IFB #: 16-541
MEXICO ROAD DETENTION BASIN RETROFIT
ADDENDUM 2

Addendum issued November 1, 2016

MEXICO ROAD DETENTION BASIN RETROFIT

DETENTION BASIN GRADING PLAN

PND-01

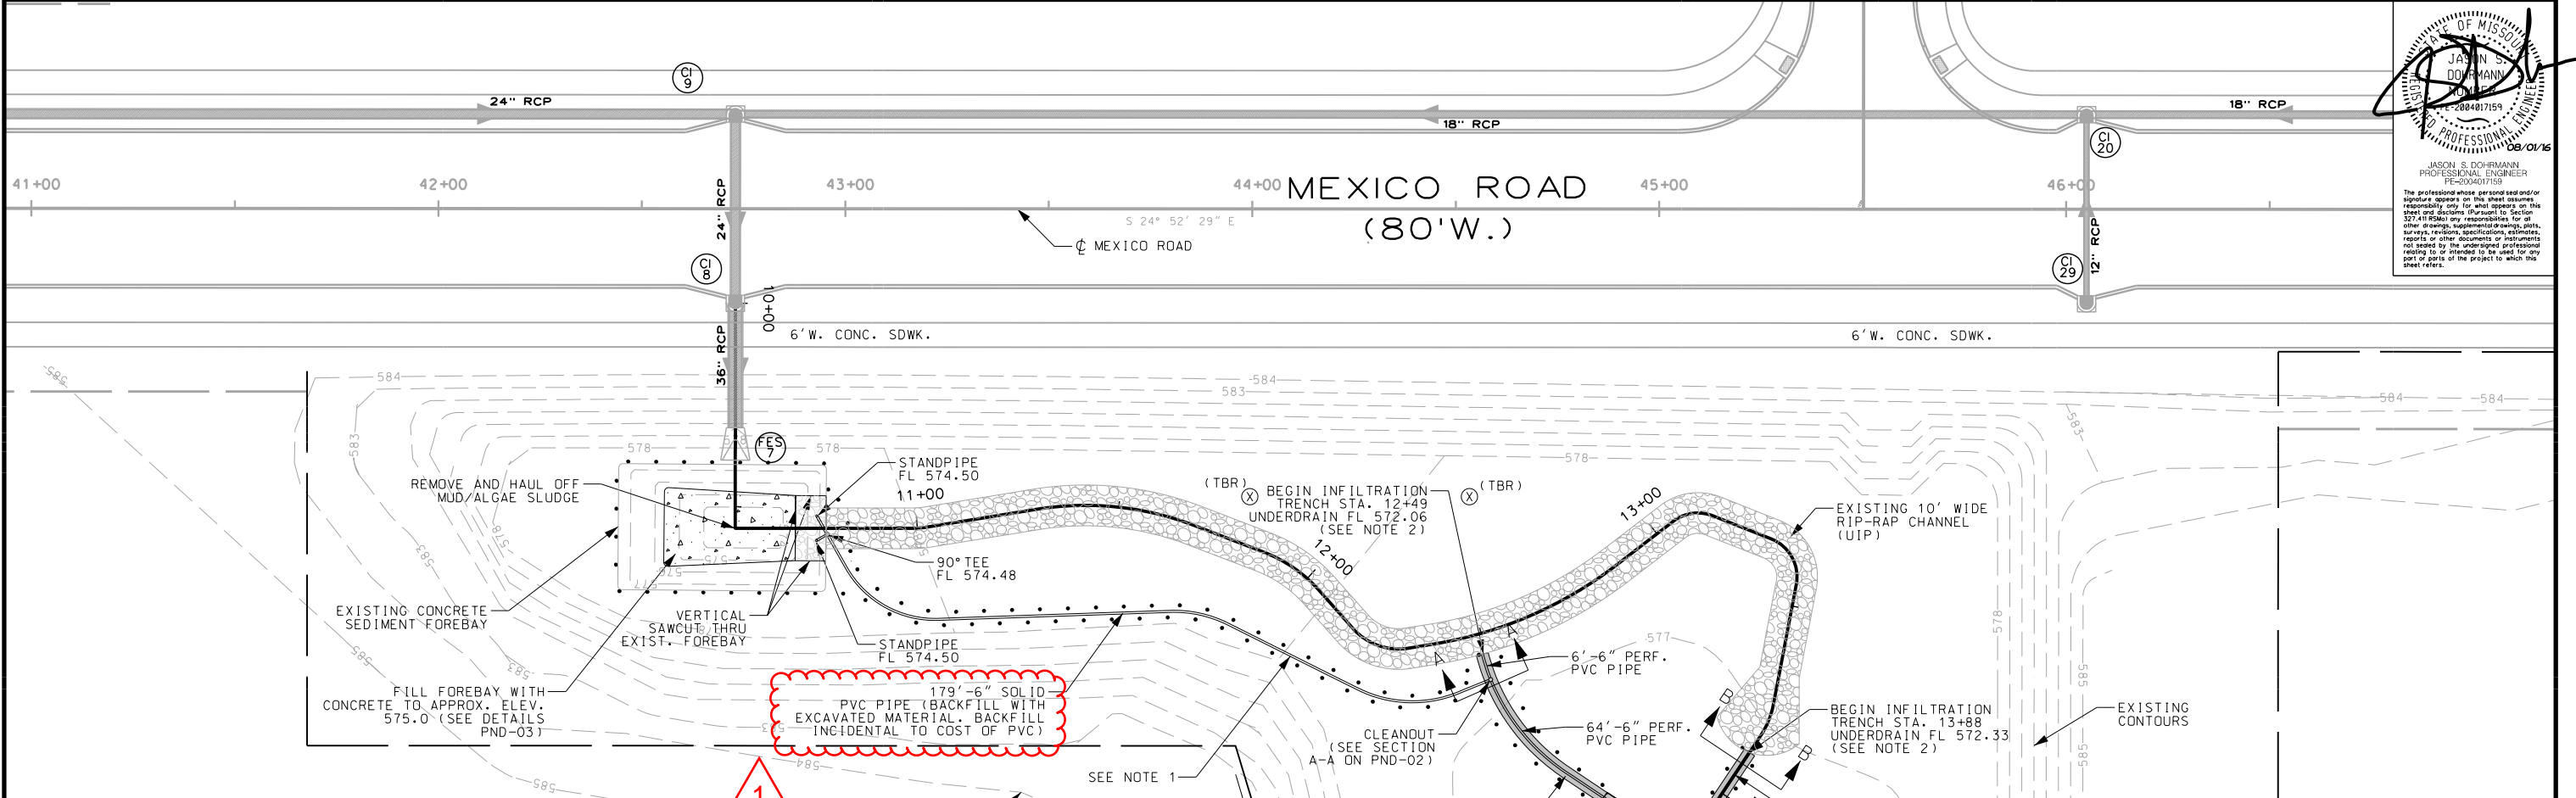
| NO. | DATE | BY | REVISION DESCRIPTION |
|-----|----------|-----|---|
| 1 | 10/28/16 | AJS | BACKFILL FOR TRENCH MADE INCIDENTAL TO PVC PIPE |

4. SOIL EXCAVATED FROM THE BASIN AREA OR SPOILS FROM THE REQUIRED TRENCHES CAN BE USED TO BACKFILL THE SOLID PVC TRENCH RUN FROM THE FOREBAY TO THE FIRST CLEANOUT. BACKFILL FOR THE SOLID PVC TRENCH TO BE INCIDENTAL TO THE COST OF SOLID 6-INCH PVC PIPE. FROM THE CLEANOUT ONWARD TO THE OUTFALL STRUCTURE, THE INFILTRATION TRENCH AND SURROUNDING AREAS TO BE BACKFILLED USING AMENDED SOILS OR OTHER MATERIALS / PLANTS AS DESCRIBED HEREIN.
